STAFF RECOMMENDATION

1902 Russell Street

Application: New construction – accessory building and reduced setbacks

District: Lockeland Springs-East End Neighborhood Conservation Zoning Overlay

1 SITE PLAN
SCALE 1/32" = 1'-0"

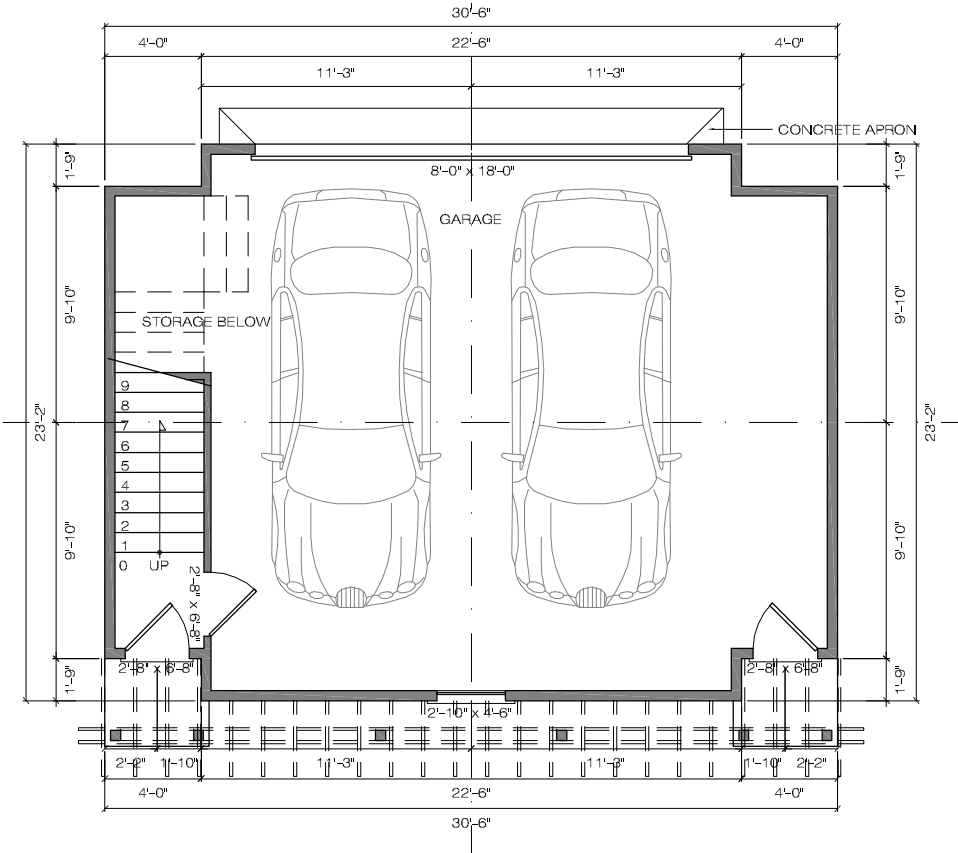
Location and Setbacks: The new accessory building will be located in the rear-left corner of the property, with an eight foot (8') rear setback and a four foot, six inch (4'-6") left side setback. This location is similar to that of historic accessory structures, but will require a reduction of the current rear setback of ten feet (10').

Recommendation: Staff recommends approval of the proposed new accessory building, with the conditions that the foundation height matches the foundation of the house and that that staff approves the window and door material, finding it to meet the design guidelines for the Lockeland Springs-East End Neighborhood Conservation Zoning Overlay.

1 FRONT ELEVATION
SCALE 1/4" = 1'-0"

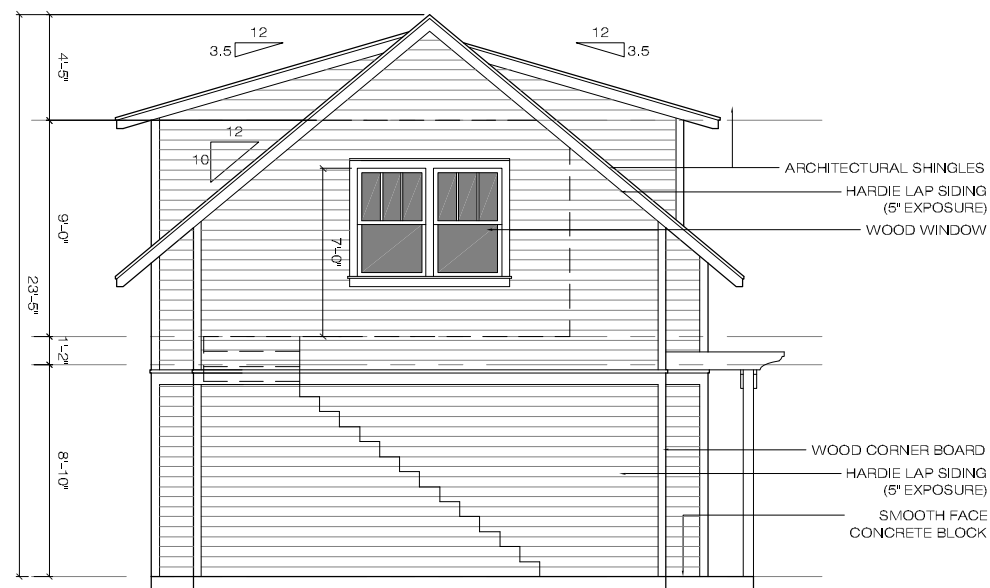
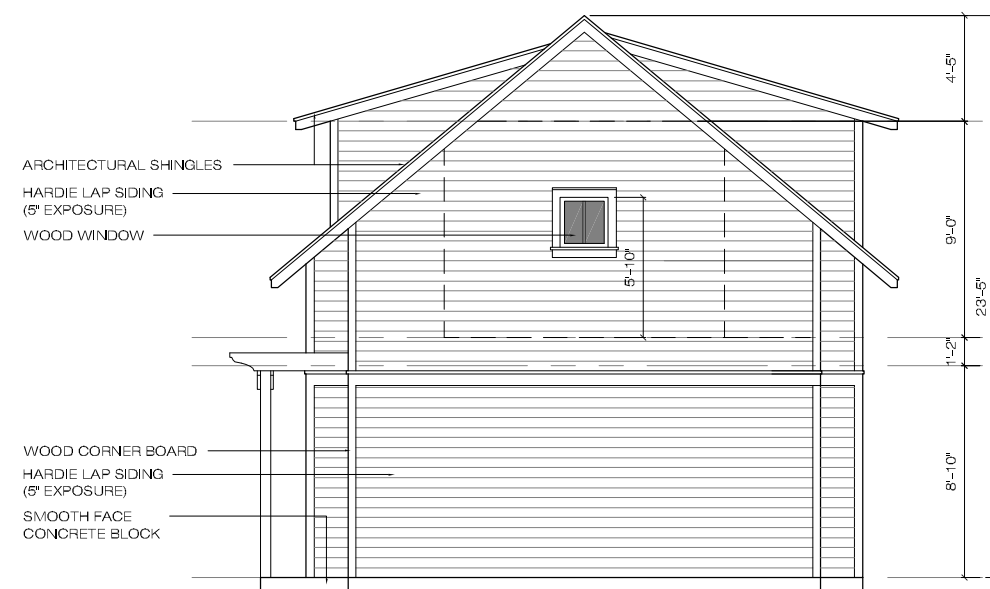
Height & Scale: The building will be twenty-four feet (24') tall with an eave height of twelve feet, six inches (12'-6"). The footprint of the building will cover six hundred, eighty square feet (680 sq. ft.), with a thirty foot, six inch (30'-6") wide front elevation. The roof will be five feet lower than the roof of the house, with the eaves matching the height of the eaves on the house. Despite having matching eave heights, the walls of the garage will appear two feet (2') taller because the house will have three courses of split-faced concrete block foundation. Exposing the foundation of the garage would make the perceived wall height of the garage more appropriate.

The primary roof of the accessory building will be a 10:12 side-oriented gable. Front and rear shed-roofed dormers will provide additional usable space in the upperstory, but the building will not be used as a dwelling. These roofs are compatible with those of the house and will meet guideline II.B.5.

Materials: The materials will be compatible with those of the house: smooth-faced cement-fiber siding with a five inch (5") exposure, cement-fiber trim, a slab-on-grade foundation, and a gray-brown fiberglass asphalt shingle roof matching the roof on the new house. The windows and pedestrian doors will be wood, and there will be a metal garage door facing the rear alley. The proportion and location of windows and pedestrian doors is appropriate for an accessory building. These materials meet guideline II.B.4. and II.B.8.a.
